*Student Fitness and Wellness Center
Renovation and Addition*

ADDENDUM No. 5

*Purdue University
1252 Third Street
West Lafayette, IN 47907-2079*

Restoration Site Contractor, Bid Package 04/32 - 2011

ISSUED WITH DR4 Addendum 05	SHEET REVISED C113
DESIGN RELEASE # 4	SKETCH NUMBER C-SK-07
PROJ # MNI# 08226	DRAWN BY HHW
DATE 12/13/2011

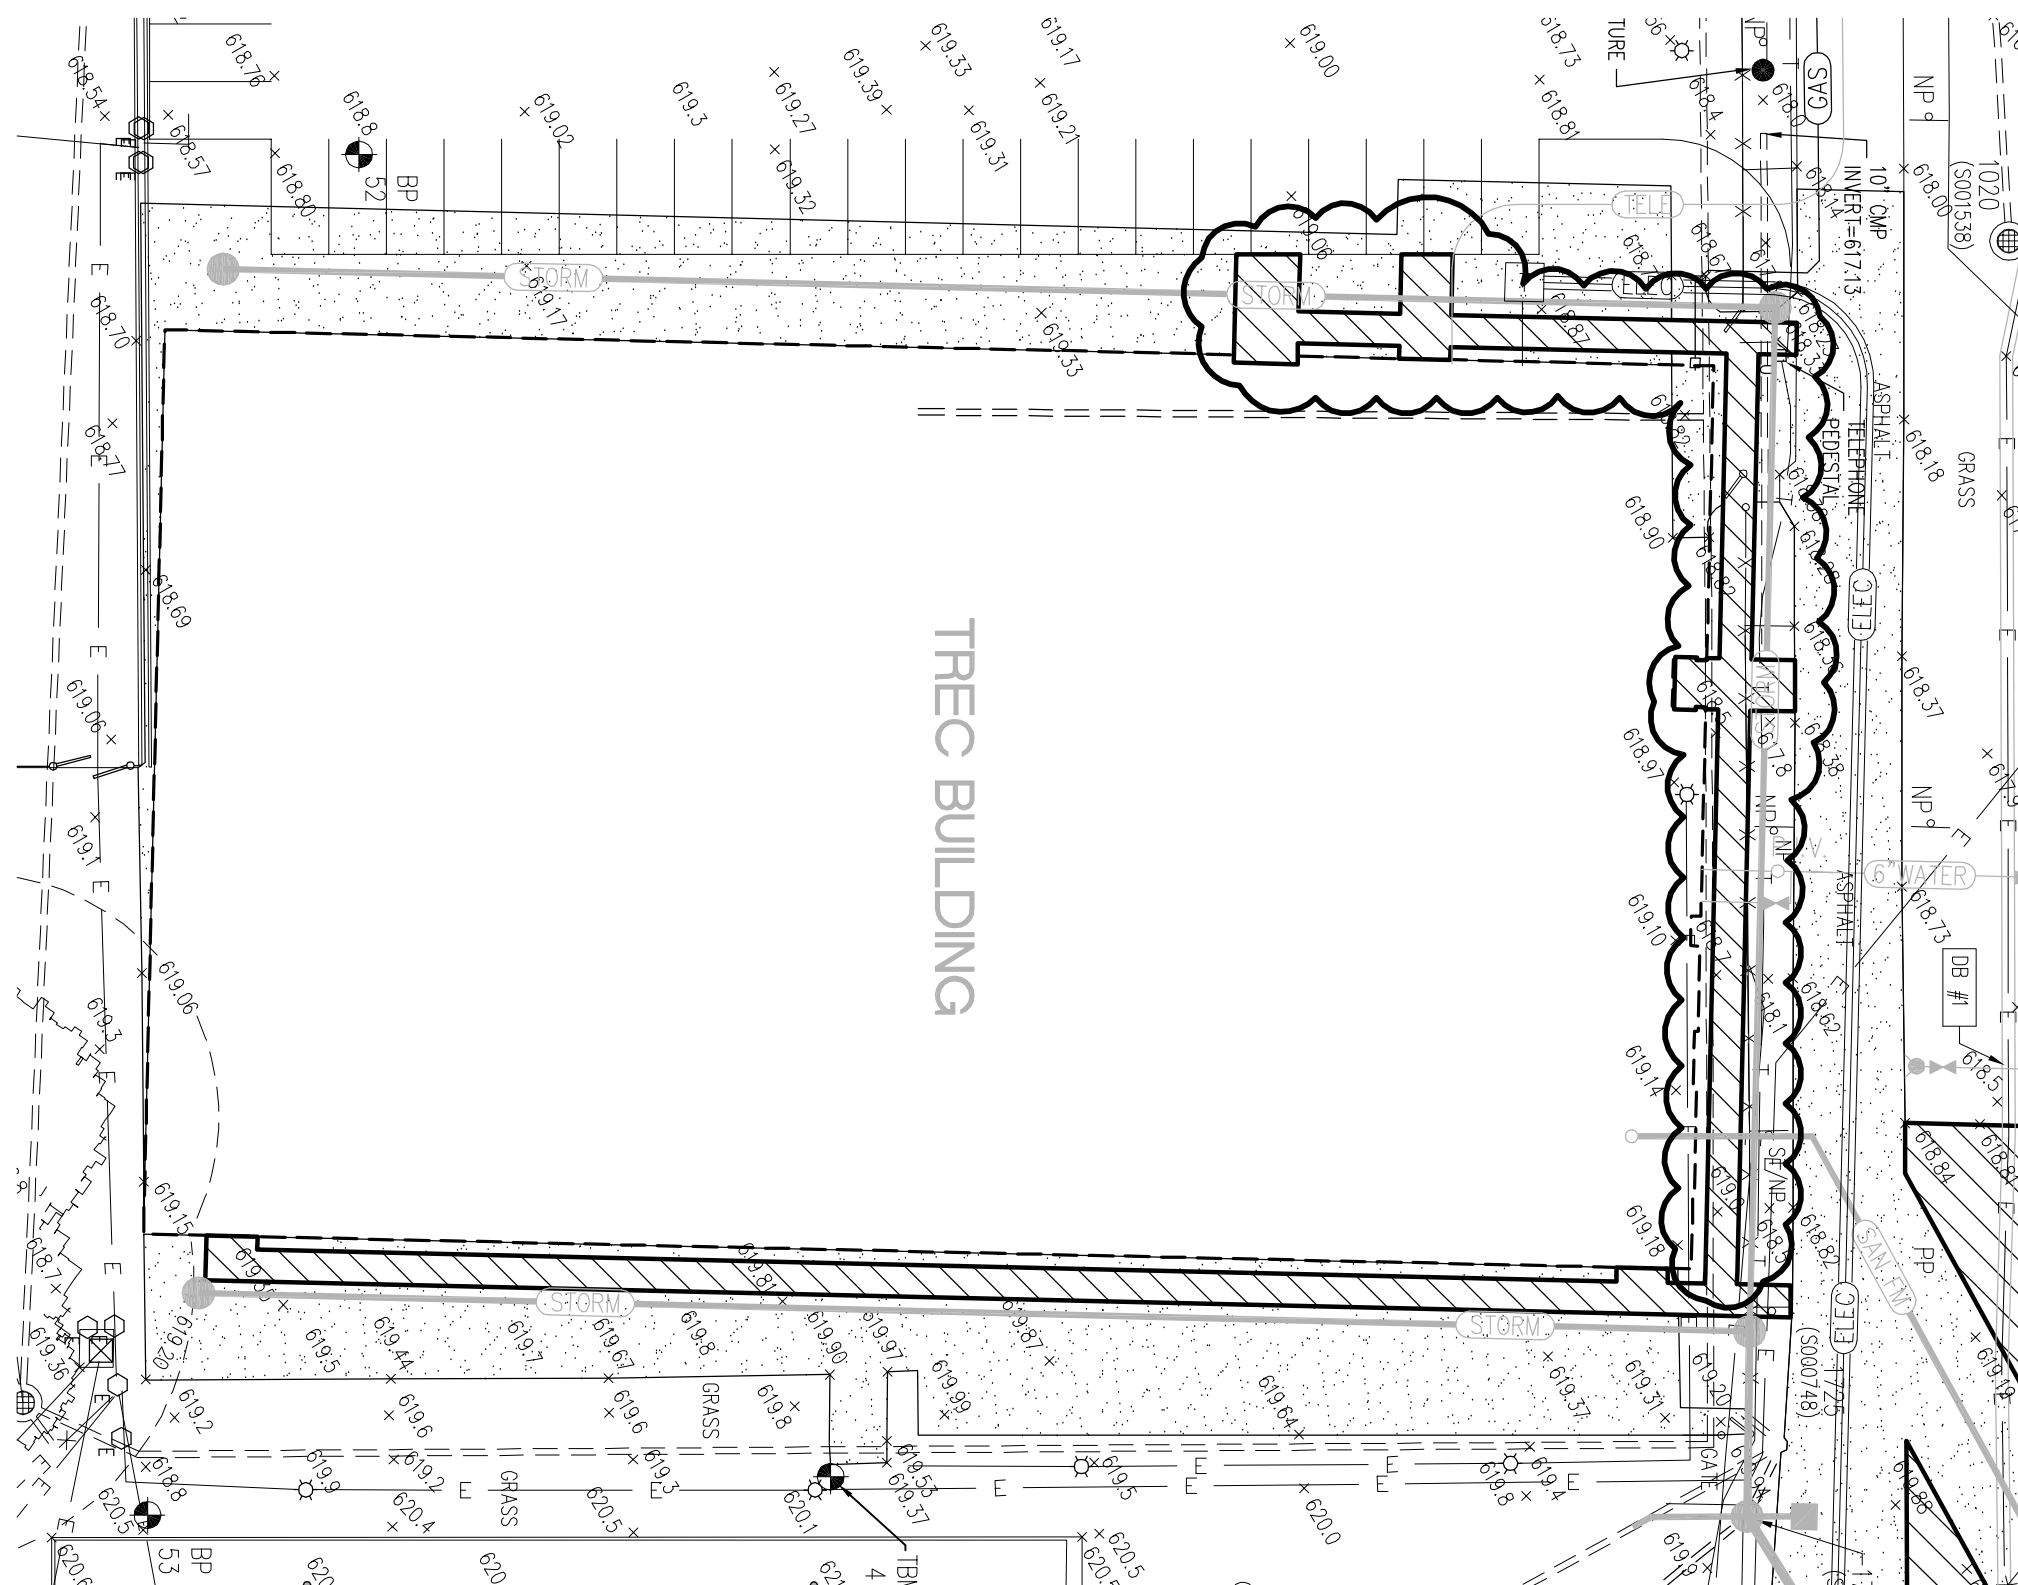
1. Revise Plan as shown on Sketch No. C-SK-07.
2. Revise Plan as shown on Sketch No. C-SK-08.
3. Revise Plan as shown on Sketch No. C-SK-09.
